DETAIL ROADWAY PLAN

Kaneohe Bay Drive Improvements
Vicinity of Puohala Street to Kawa Bridge
Federal Aid Project No. STP-065-1(9)

2/3/03	Revised Driveway Per Adendum No. 1
--------	------------------------------------

ADD. 38

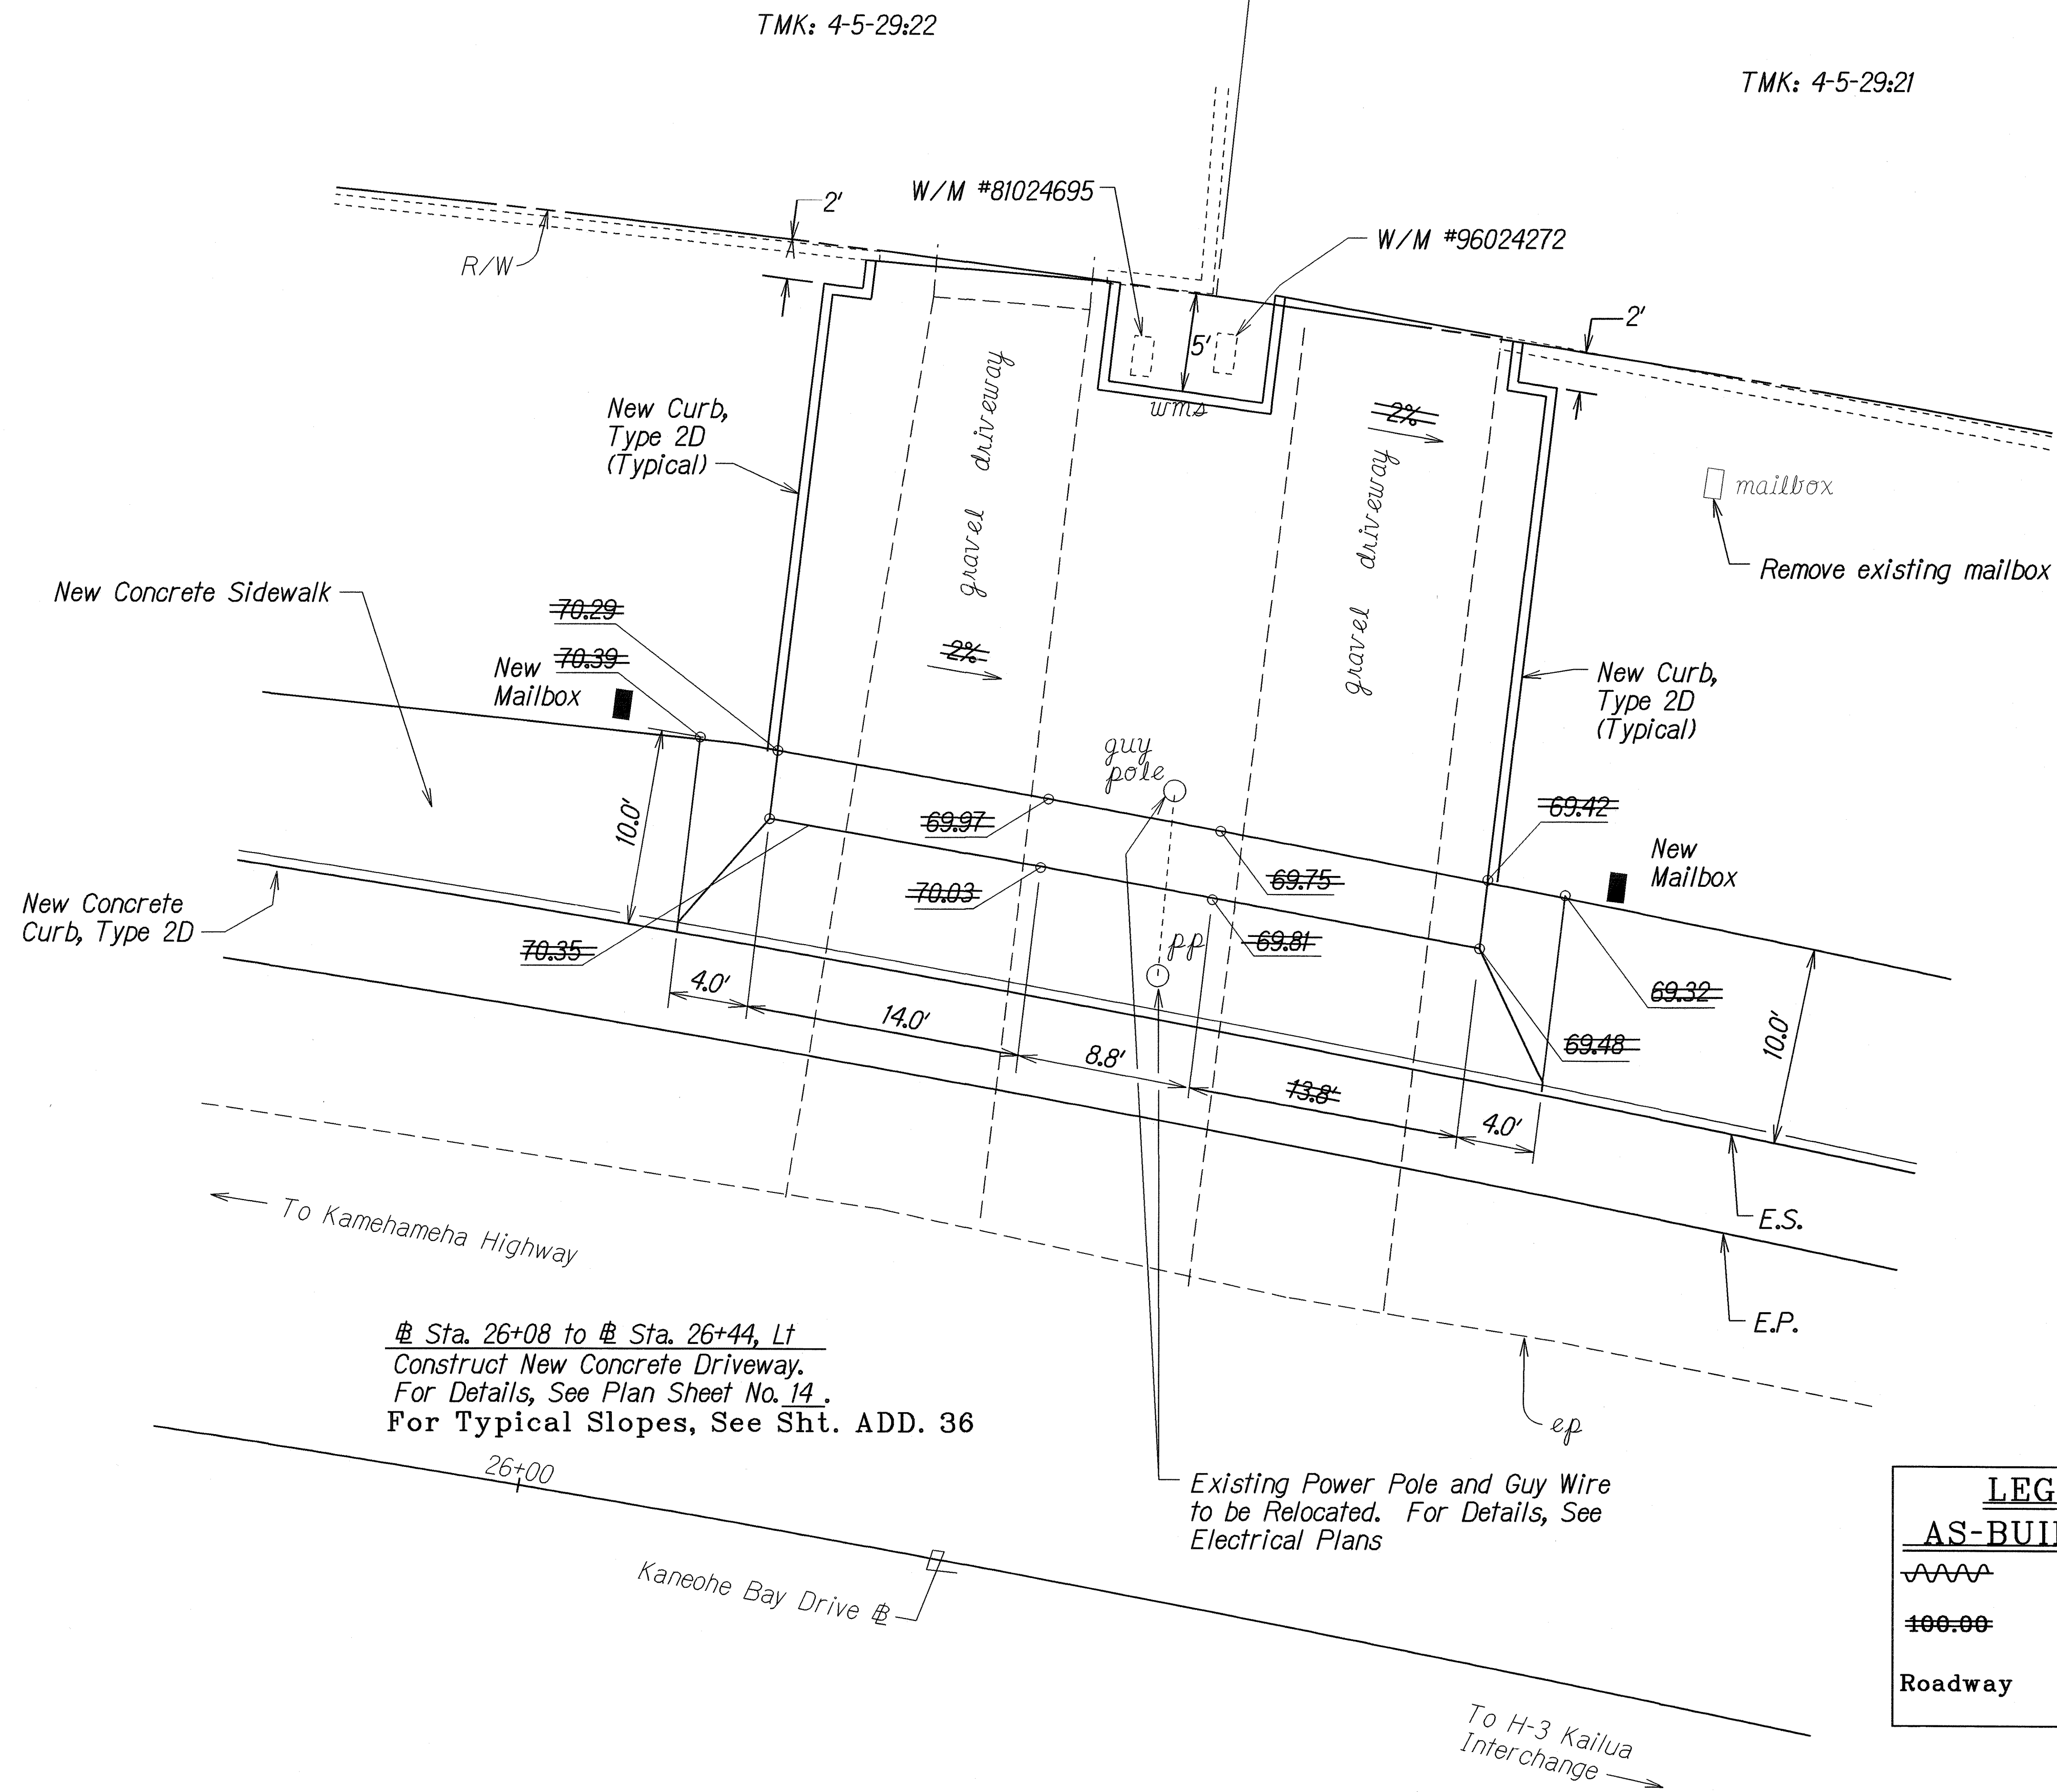
2/3/03 Revised Driveway Per Addendum No. 1

Sta. 26+08 to Sta. 26+44, Lt
Construct New Concrete Driveway.
For Details, See Plan Sheet No. 14.
For Typical Slopes, See Sht. ADD. 36

ADD. 39

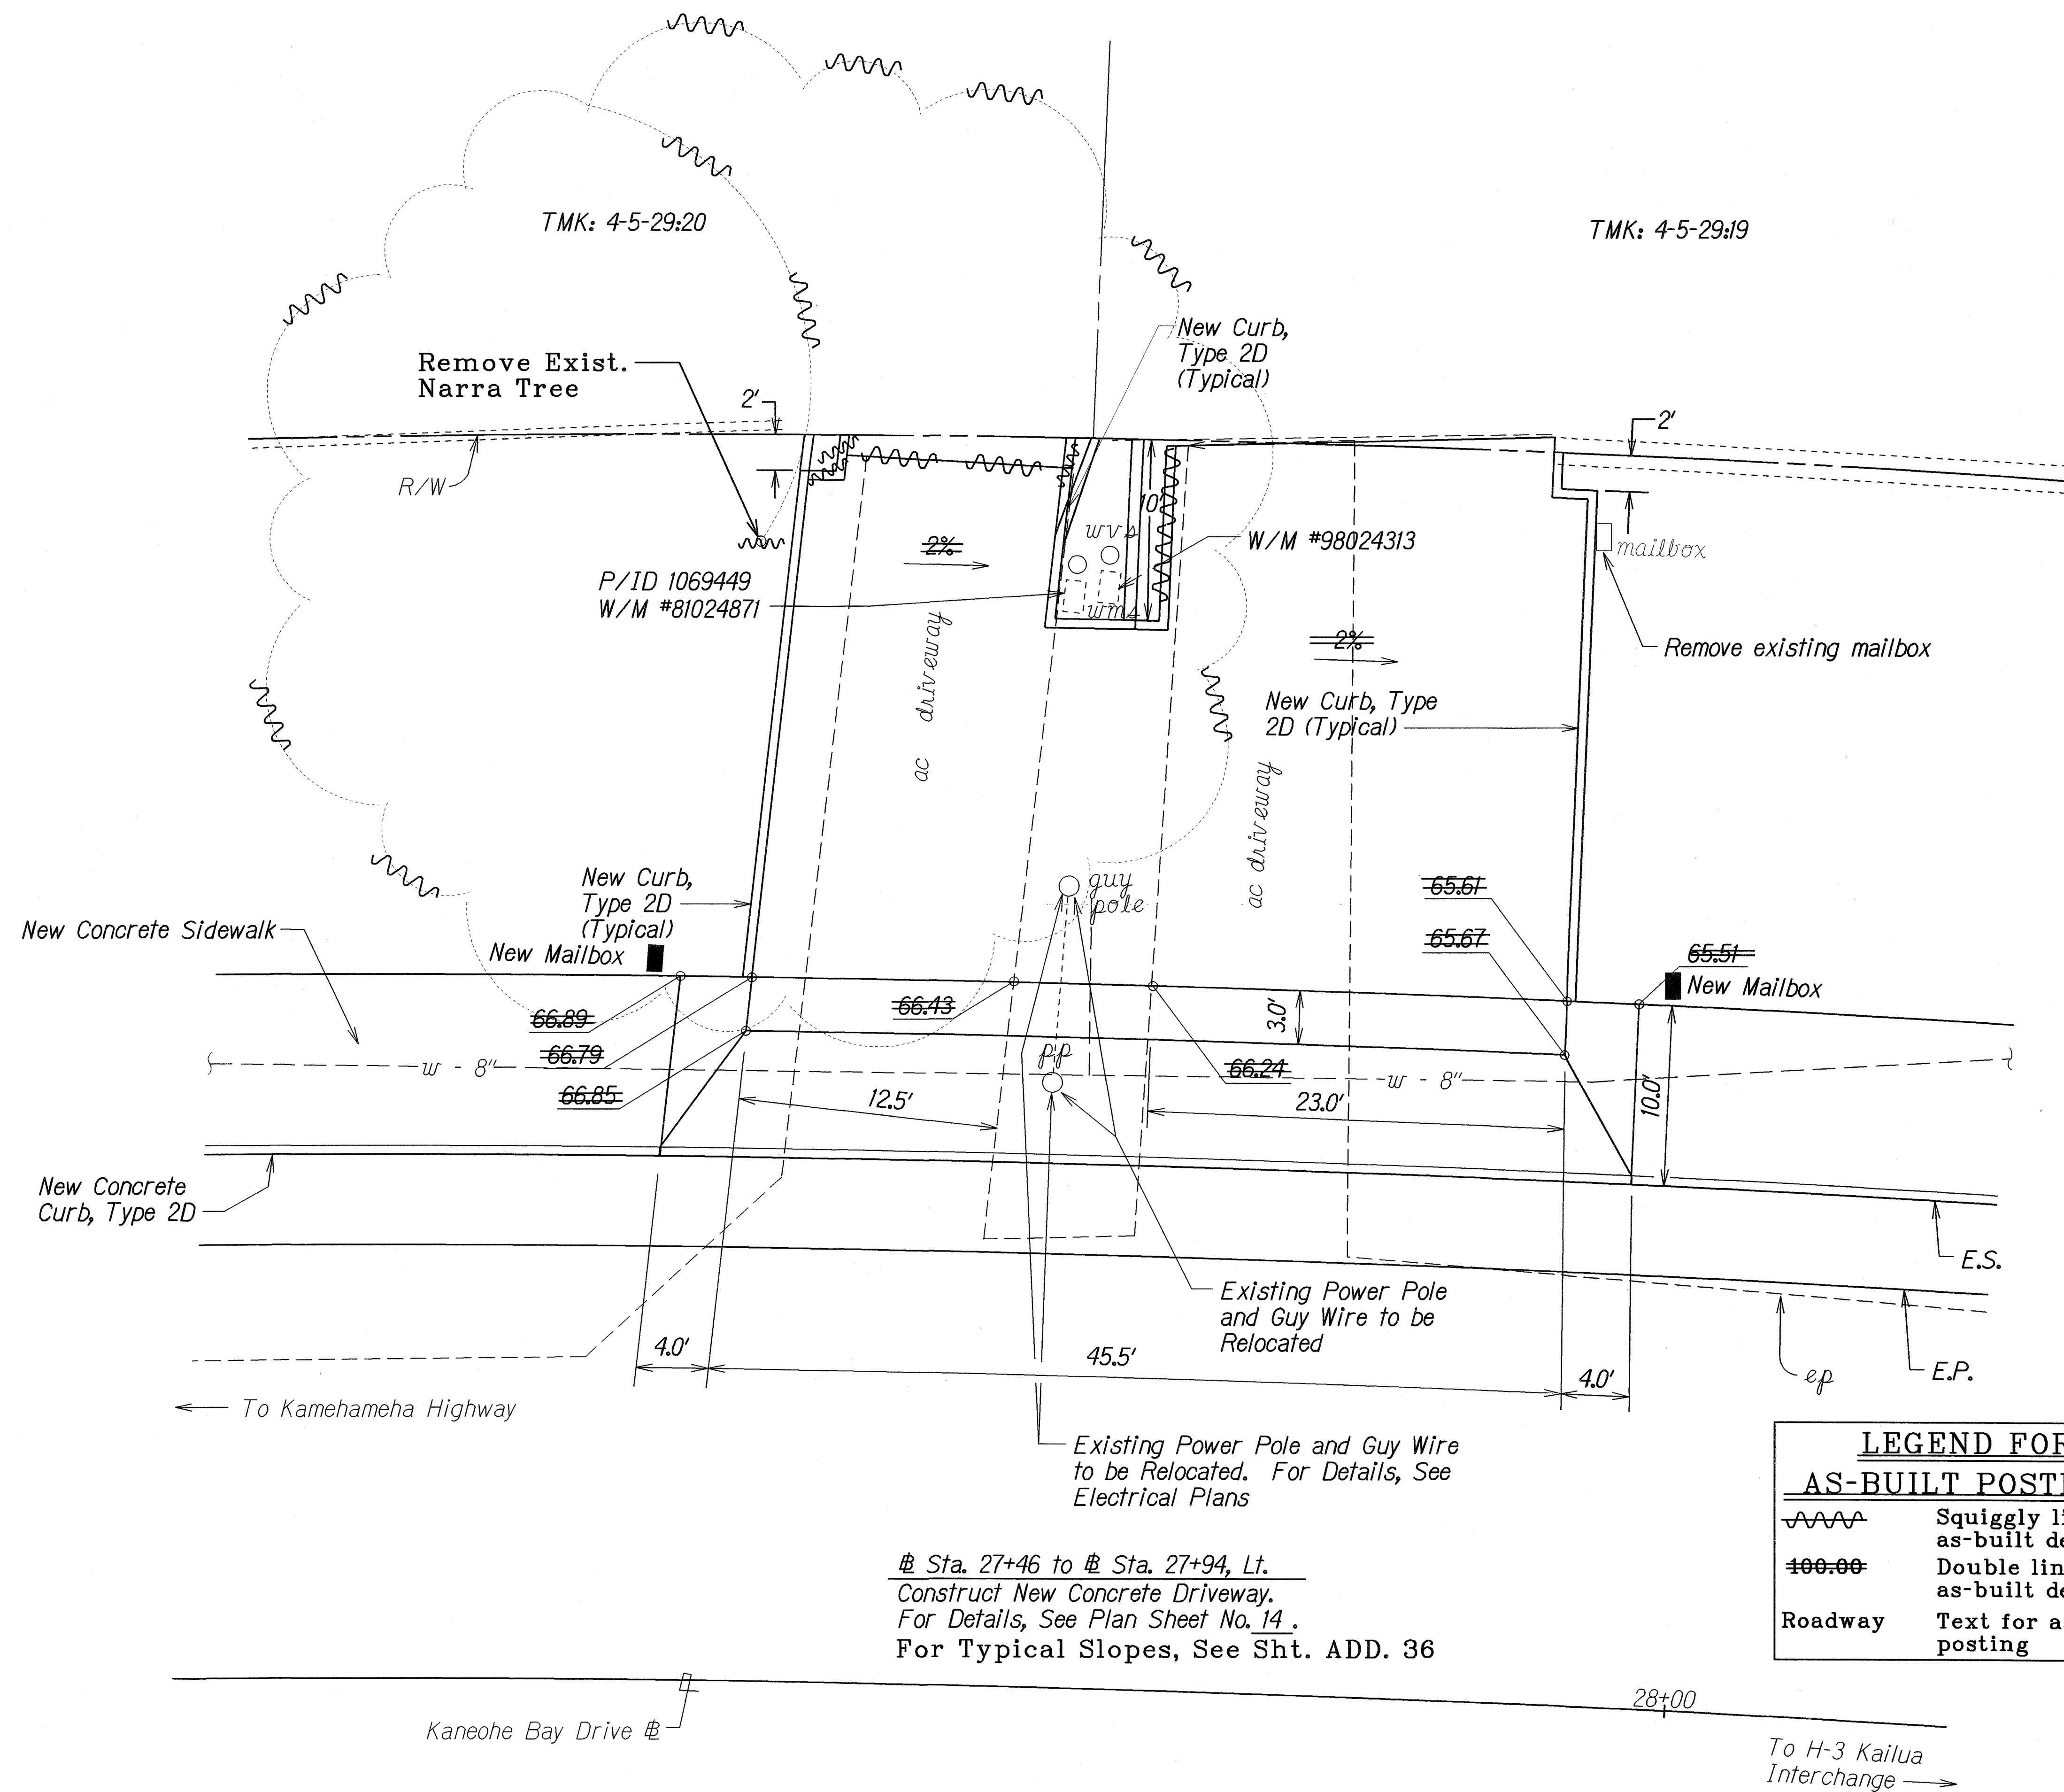
2/3/03	Revised Driveway Per Addendum No. 1
--------	-------------------------------------

Sta. 27+46 to # Sta. 27+94, Lt.
Construct New Concrete Driveway.
For Details, See Plan Sheet No. 14.
For Typical Slopes, See Sht. ADD. 36

STATE OF HAWAII
DEPARTMENT OF TRANSPORTATION
HIGHWAYS DIVISION
DETAIL ROADWAY PLAN
KANEHOE BAY DRIVE IMPROVEMENTS
Vicinity of Puohala Street to Kawa Bridge
Federal Aid Project No. STP-065-1(9)
Scale: 1"=5' Date: June 2001
SHEET No. 6 OF 9 SHEETS

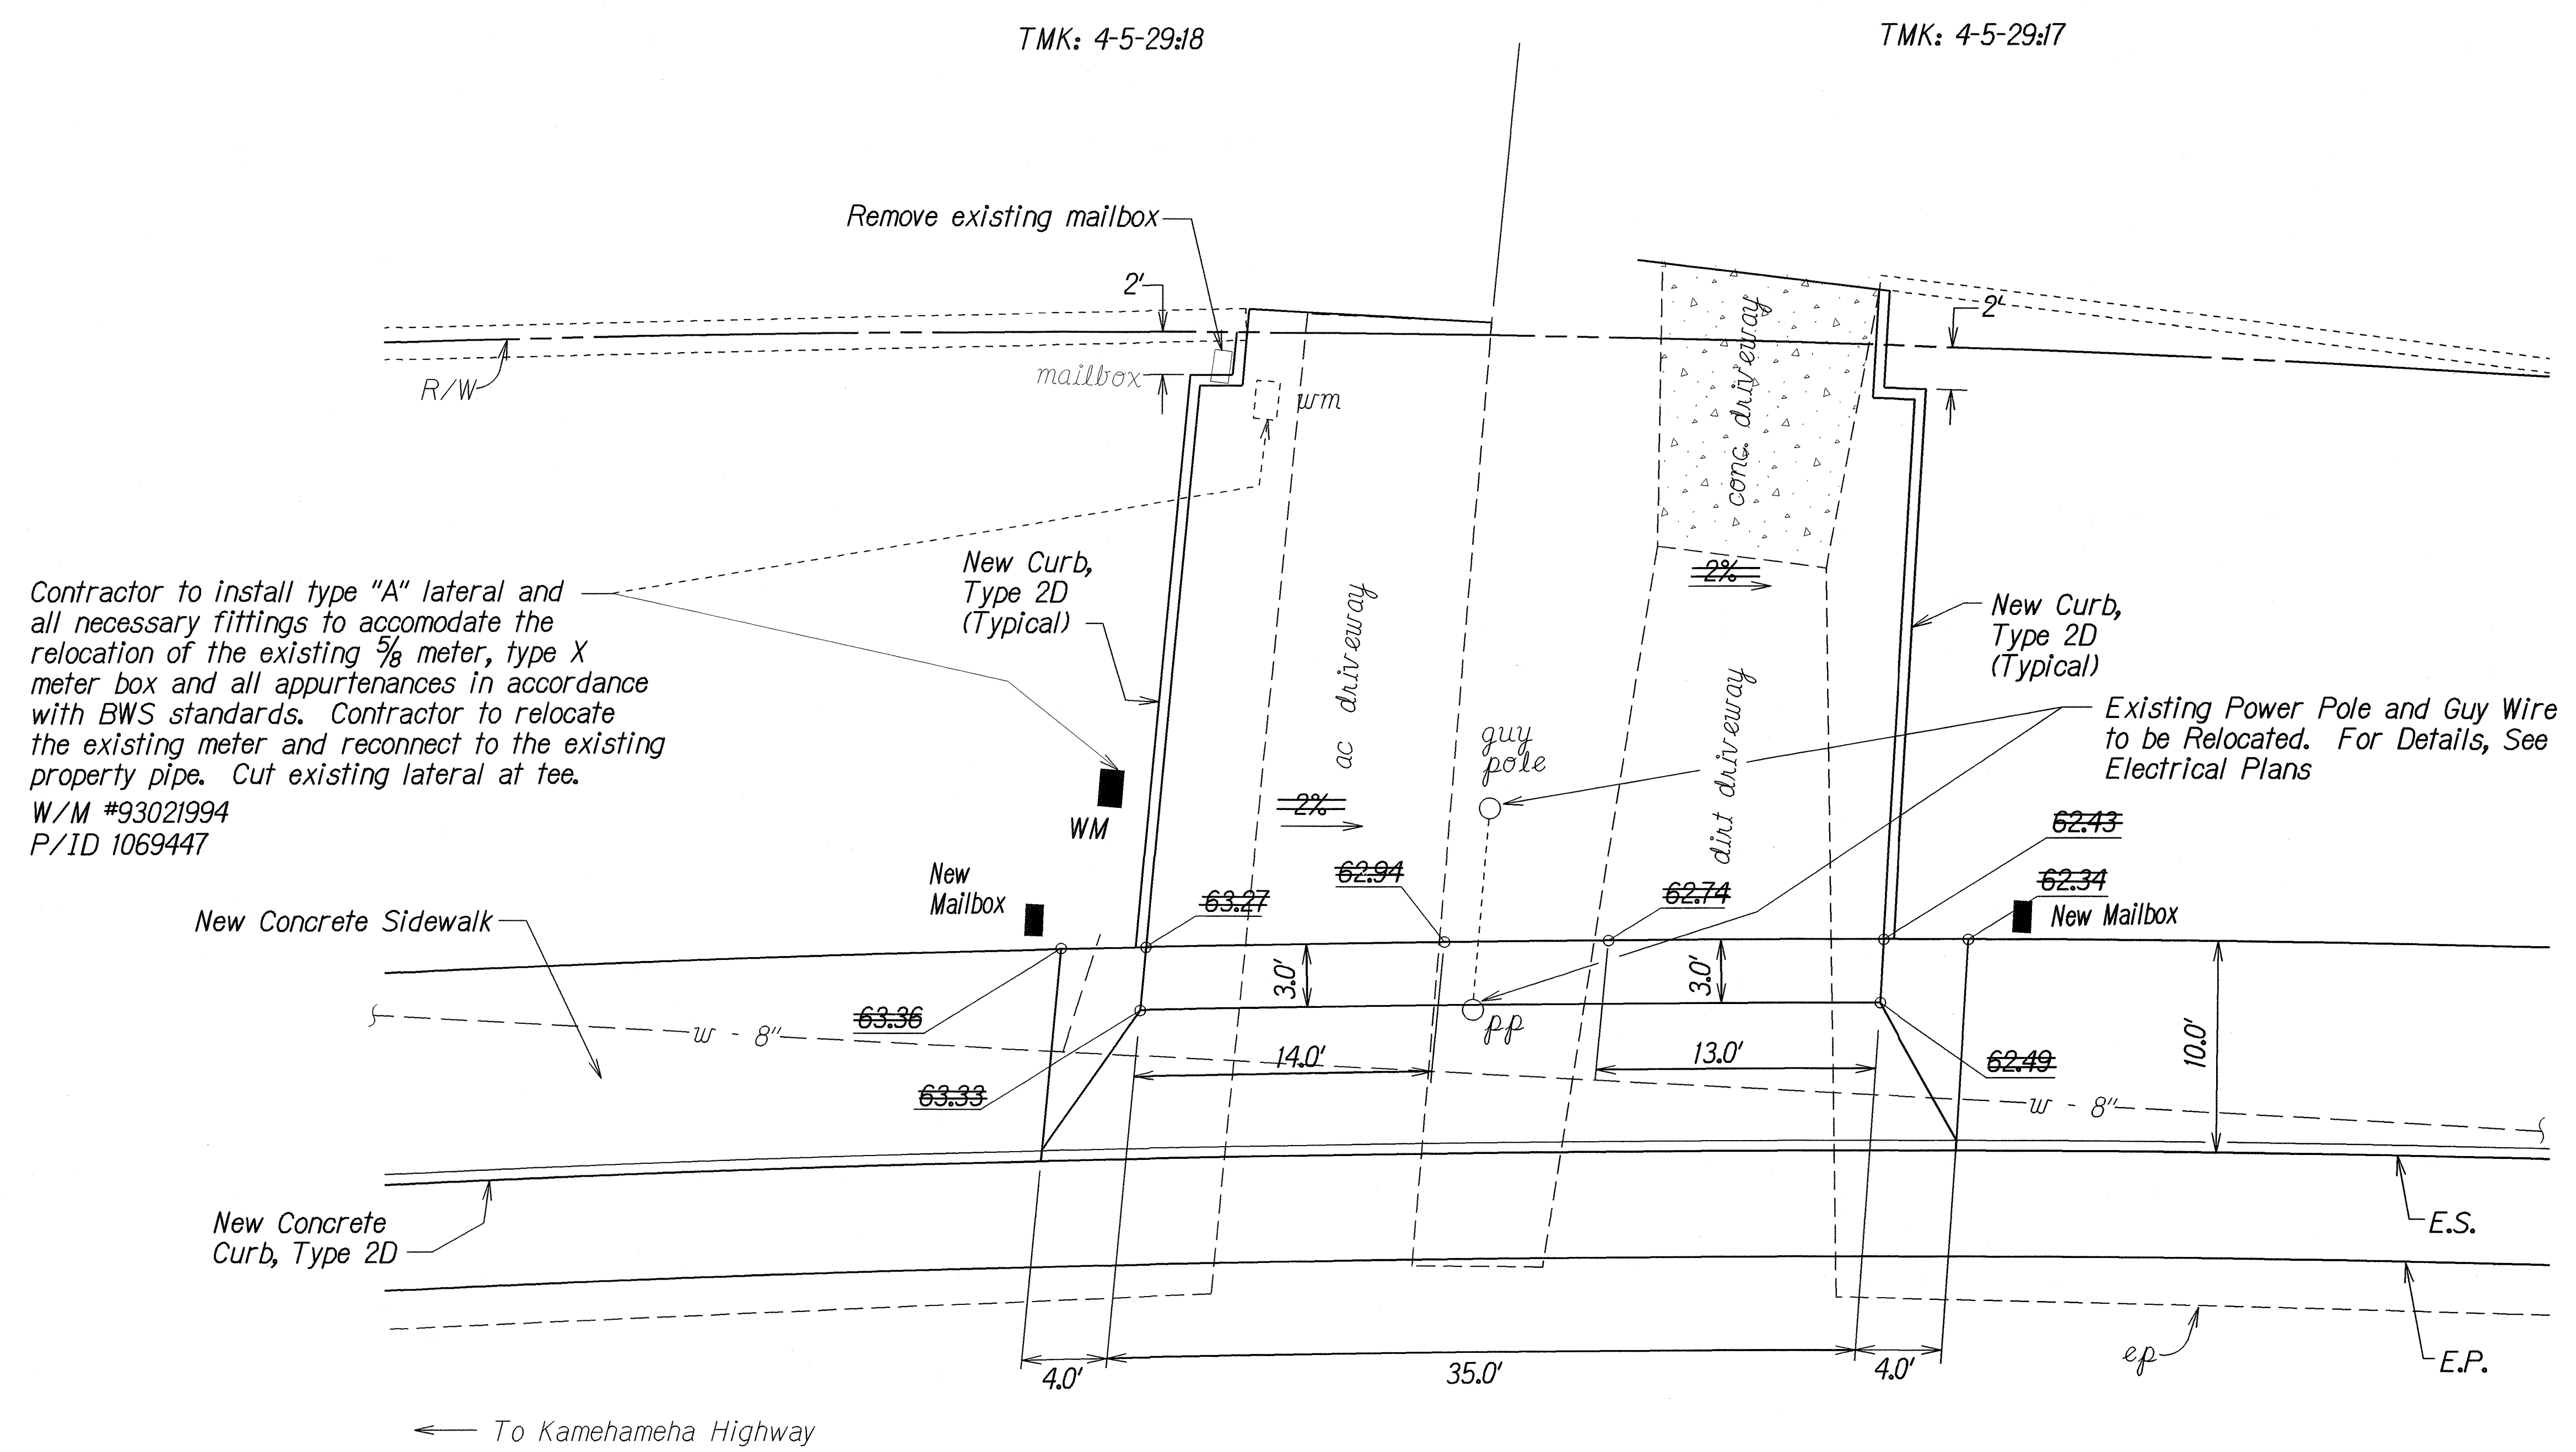
2/3/03 Revised Driveway Per Addendum No. 1

± Sta. 28+91 to ± Sta. 29+27, Lt.
Construct New Concrete Driveway.
For Details, See Plan Sheet No. 14.
For Typical Slopes, See Sht. ADD.36
